# Design Review Board

# DRB25-00372

## Van Horn Aviation

- Design Review
- To allow for an aircraft hangar

③ SOUTH ELEVATION - COLOR  
1/8" = 1'-0"

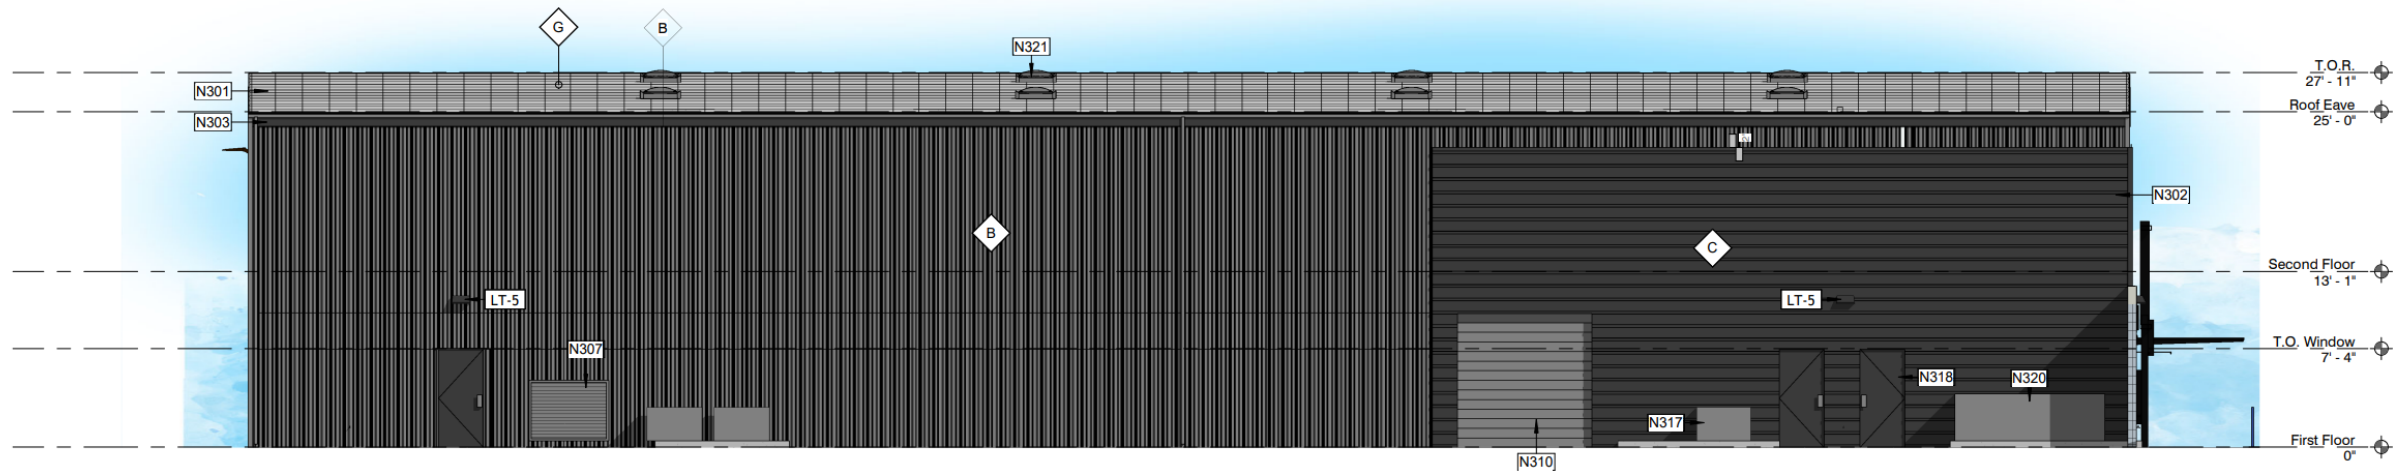
- ✓ Amount of metal panel siding used on the front (south) elevation
- ✓ The scale of the recesses and projections along the south elevation
- ✓ The proportion of the canopies and “struts” along the south elevation
